**Before the Hearings Panel
At Waimakariri District Council**

In the matter of the Proposed Waimakariri District Plan

Council reply on Rezoning requests – Oxford and Settlement Zone (Ohoka and Woodend Beach) – Rachel McClung on behalf of Waimakariri District Council

Date: 5 July 2024

Figure 1 – 6 York Street – Waimap 'Deposited Land Parcels' map

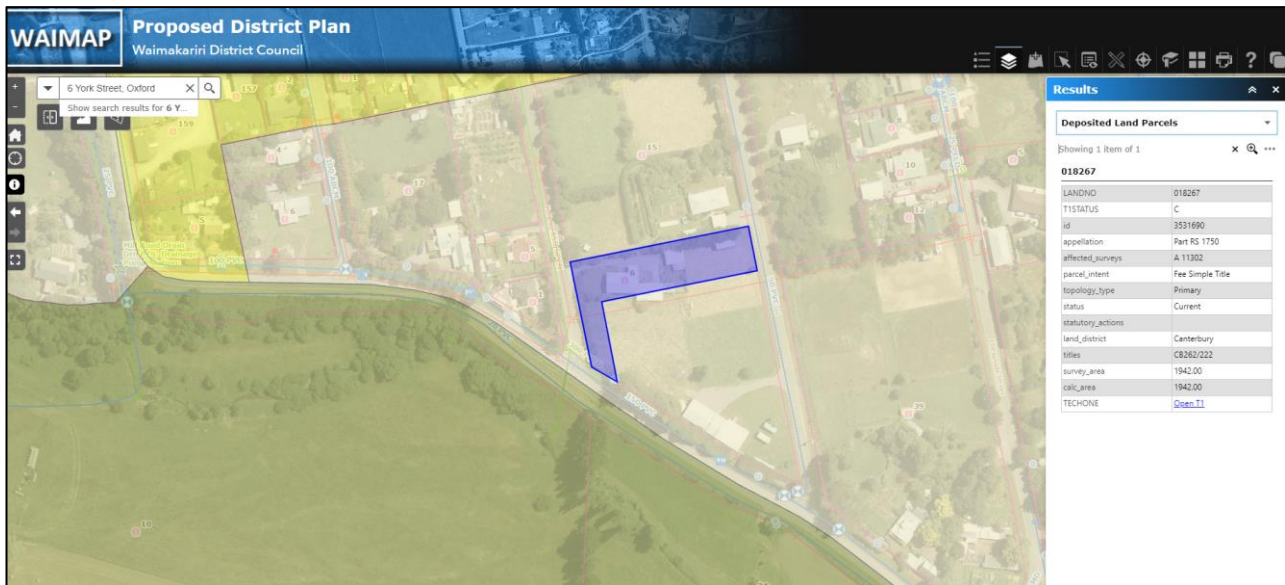
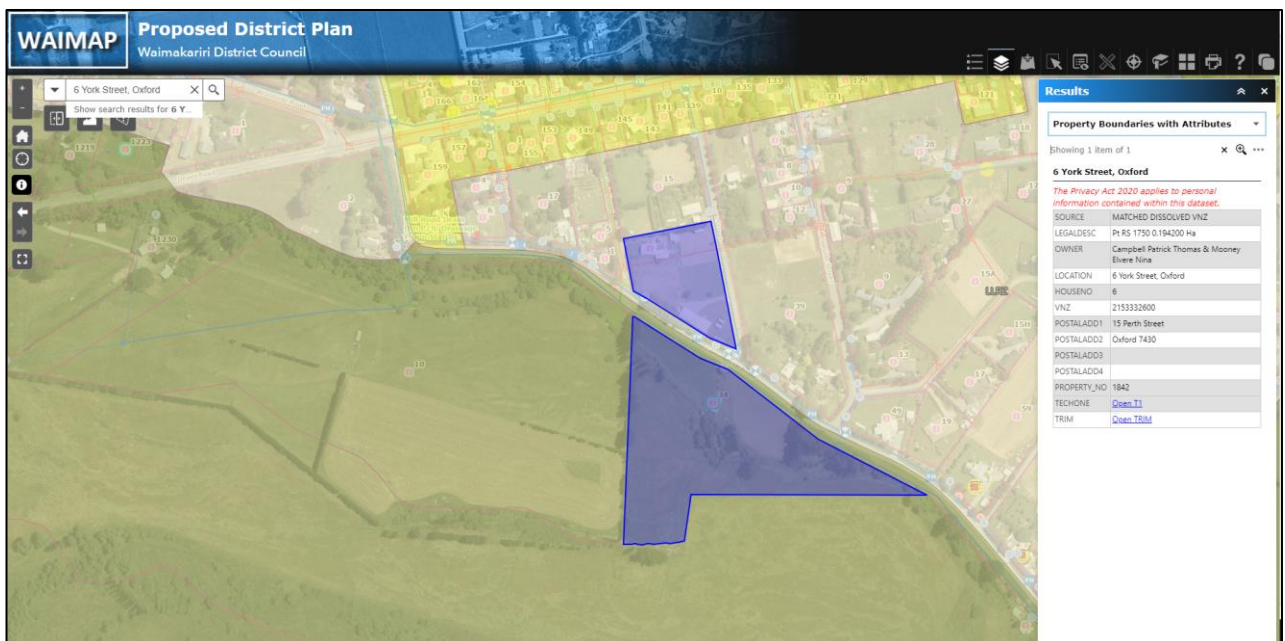
36 With regard to 6 York Street, the boundary line exists. The source I used for the figures in my s42A report was the 'Property Boundaries with Attributes' layer in Waimap. This is the layer that is used in the District Plan Planning Maps. It is derived from parcels that share a ratings assessment number and that make up one rating unit, but does not always show all parcel boundaries when the Aerial Basemap is turned

on. There is an alternative layer in Waimap called 'Deposited Land Parcels' which does shows 6 York Street as a separate land parcel (Part RS 1750) and Record of Title (CB262/222). Please refer to **Figure 1** and **Figure 2** below.

Figure 3 – 6 York Street – Planning Map with Aerial basemap turned off

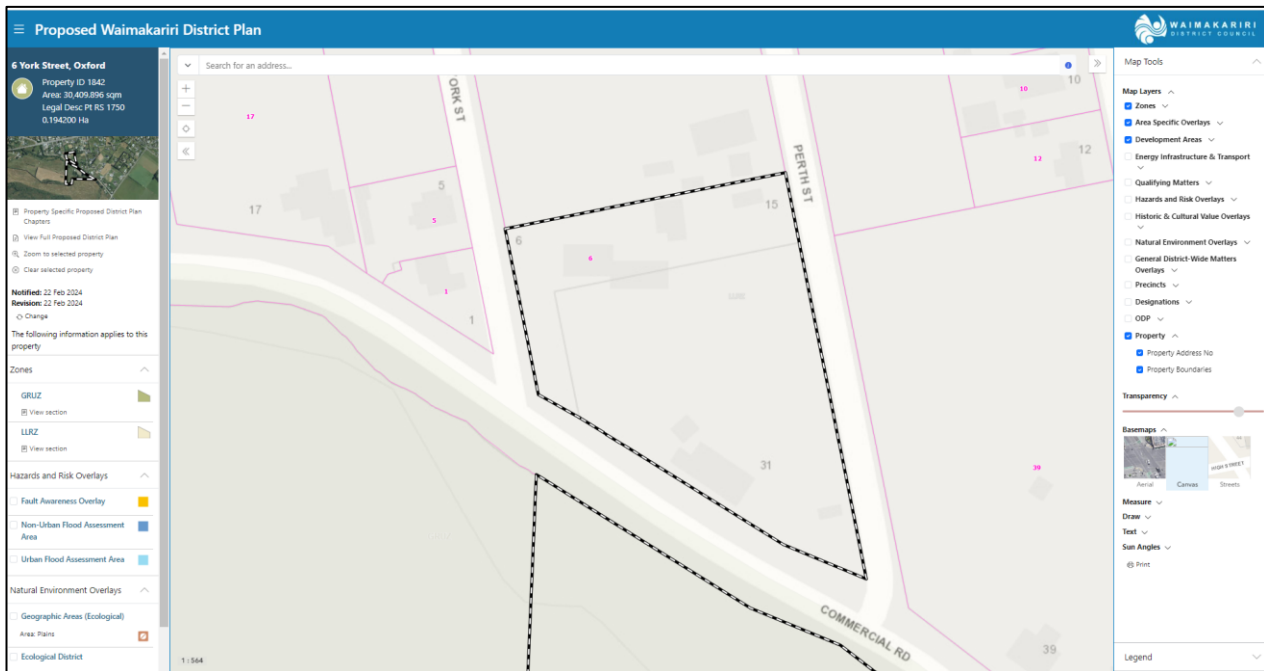
37 If the 'Aerial' Basemap is turned off on the Planning Maps, and if the 'Transparency' layer is reduced, then both the 'Canvas' and 'Streets'

basemaps do show a faint line for this parcel boundary. This can be seen in **Figure 3** below. This is a level of technical detail that will not be obvious to many first-time users of the planning maps, and I apologise to Mrs Elvere Mooney for the confusion this will have caused in reading the report.

Figure 4: Landonline screenshot of Commercial Road, Oxford abutting 31 and 34 Commercial Road.

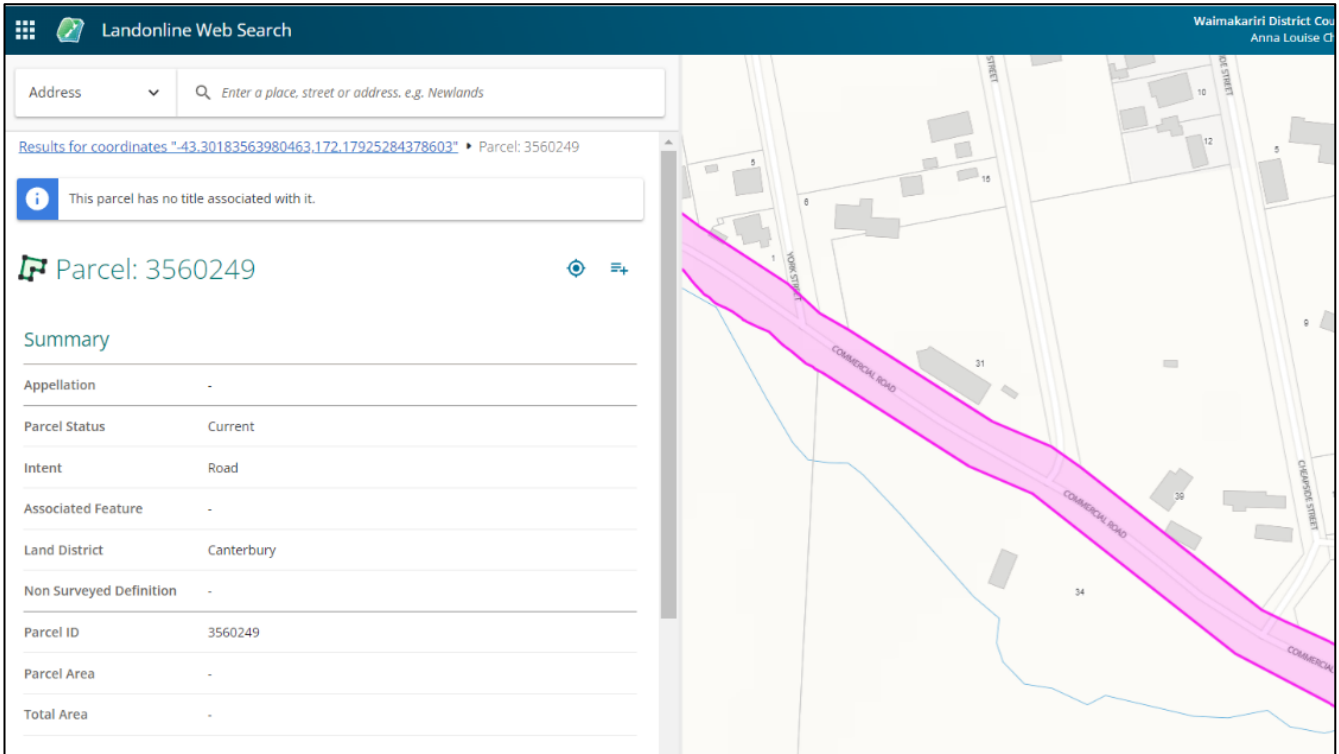
38 With regard to the ownership of Commercial Road, I have queried this with Ms Anna Childs, Property Acquisitions & Disposals Officer within the Council’s Property Team. Ms Childs checked both the Record of Title provided by Elvere Mooney and the Landonline database. Ms Childs confirmed that the Commercial Road is noted as ‘Road’ on Landonline, and is therefore in Council ownership. Ms Childs also confirmed that roads themselves do not have Records of Titles and do not require an encumbrance when they have previously been legally vested as road.

39 Ms Childs has provided the below screenshot (Figure 4 below) from Landonline showing the intent of Commercial Road as ‘Road’.

DEV-SOX-APP1 Southeast Oxford ODP

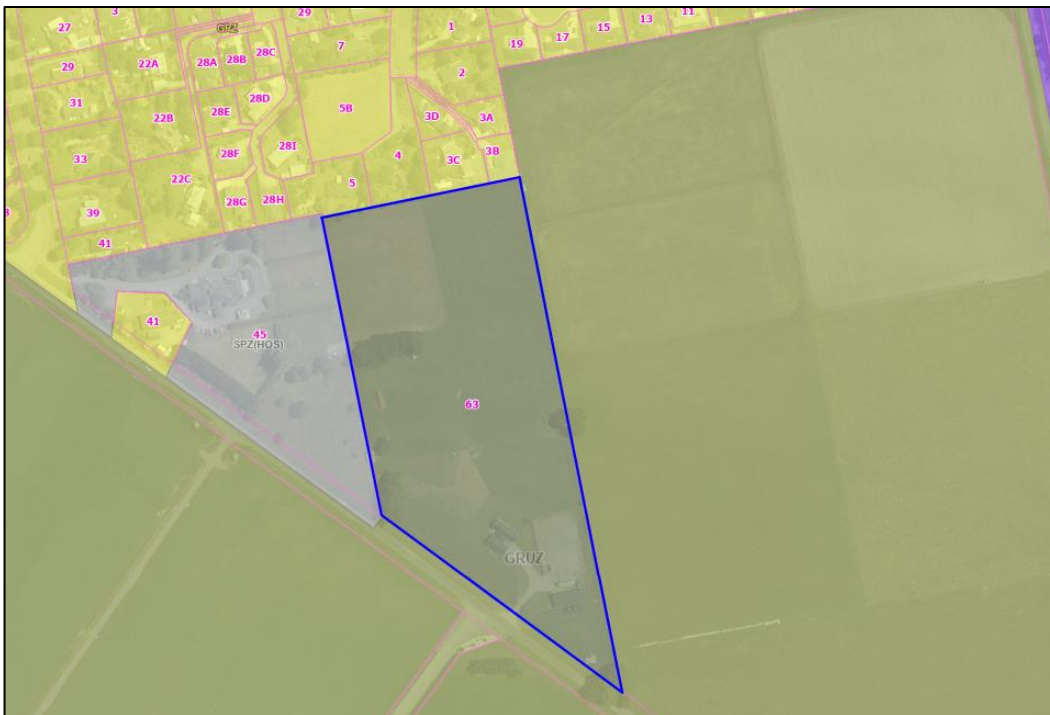
Insert new Southeast Oxford Development Area and ODP, and amend planning map to rezone 53 Harewood Road to GRZ as follows:
